Inconsistent signal detect rules

(comments I-433, I-436, R1-289, R1-290,
R1-291, R1-292, R1-293, R2-197)

Comment R2-197

Figure 180-2—Block diagram for 800GBASE-DR4 transmit/receive paths

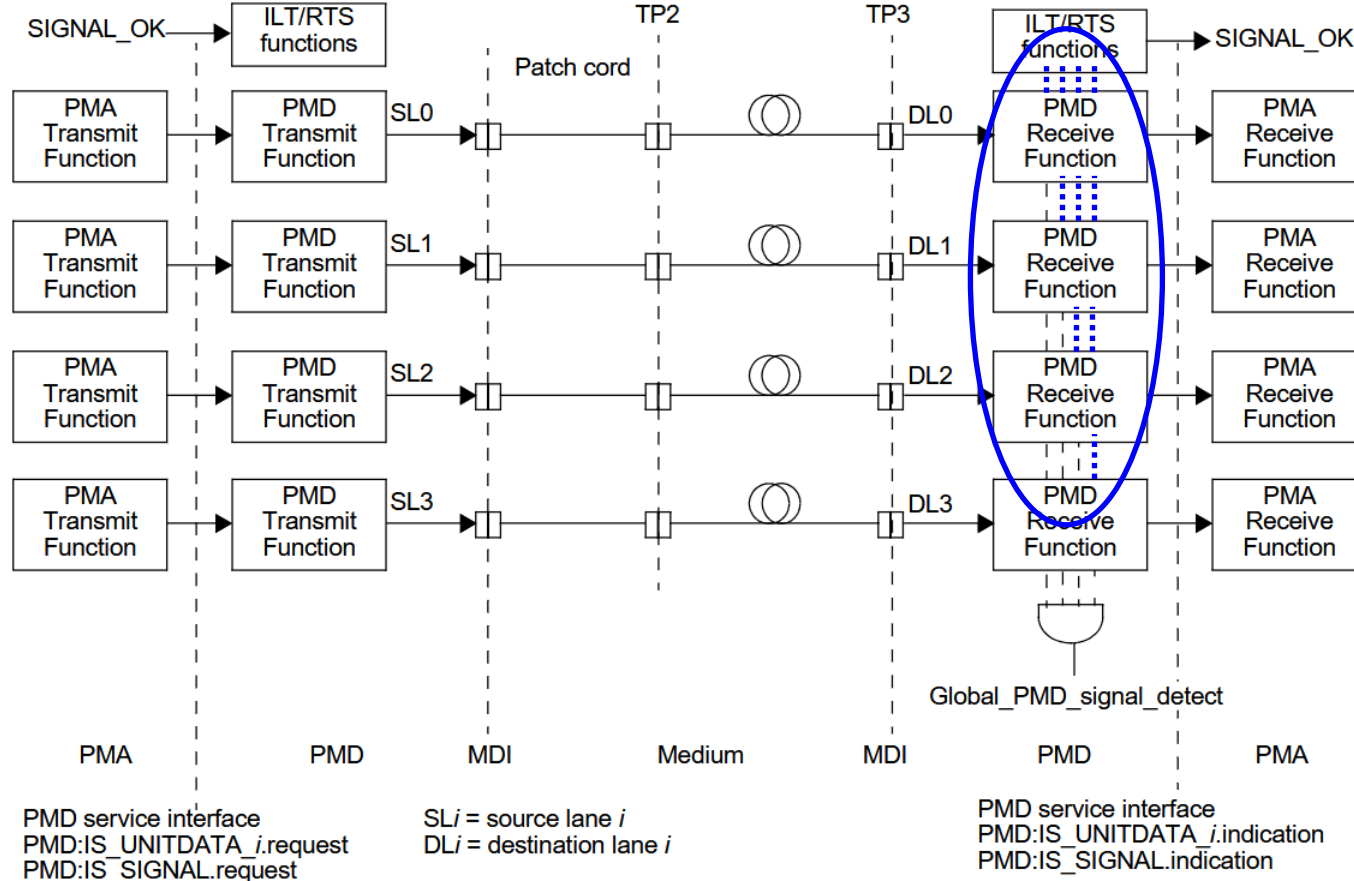
- R2-197 SC 180.5.1 P 468 L 27 TR
- As previously pointed out, Figure 180-2 (block diagram) indicates that signal detect is disconnected from SIGNAL_OK, contrary to all optical PMDs. 180.5.5 says "This standard imposes no response time requirements on the generation of the PMD_signal_detect_i variable." It turns out that they are connected and timing is important: see 178B.8.3.1 as revised: rx_ok "it shall be set to false when an input signal corresponding to tx_disable = true in the peer is received for 100 ms (the minimum duration of the quiet_timer) or longer". As the criterion for tx_disable = true is Average launch power of OFF transmitter ≤ -15 dBm, which is the criterion in Table 180-5, Signal detection criteria for each lane: "Average optical power at TP3 ≤ -15 dBm", signal detect IS required, AND its timing is required (which is new and would surprise optical engineers if they read it).

- Add lines to show that lane-by-lane SD goes to APSU
- Or, remove the lines, the gate and Global_PMD_signal_detect, to match Tx , and because we don't usually draw individual management status variables in block diagrams

- Revise Figure 180-2 and 180.5.5 to be consistent with 178B.8.3.1, with appropriate cross-references. Similarly in other optical clauses.
